## Mini Cooling Fan Resistor Repair Upgrade

Part# 17 11 7 541 092-PRM

### OEM Design

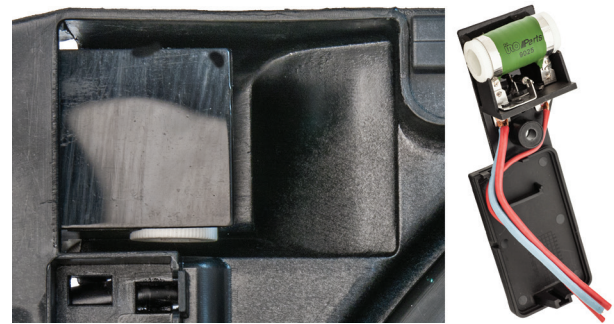
The Mini Cooper suffers from a common failure of the main cooling fan motor speed resistor, which causes the fan to either stop operating or never shut off. Mounted at the front of the radiator inlet grille, the OE design exposes the resistor to harsh weather elements, promoting corrosion and eventual failure. Mini only offers this resistor as part of the costly complete cooling fan assembly.

- Resistor coil is exposed and unprotected
- Rain, snow, pollutants, blowing sand and flying road debris eventually damage or corrode the resistor winding

ÜRO Parts developed a repair kit for this cooling fan speed resistor pack that not only saves money by replacing only the failed component, but also provides a more robust repair. The ÜRO Parts Premium Resistor Kit provides a new resistor pack which is similar to the OE design, and adds a durable plastic shield to help protect the resistor coil.

- Protective cover helps shield fragile resistor coil from harsh weather elements, blowing sand, and airborne gravel
- Lifetime warranty
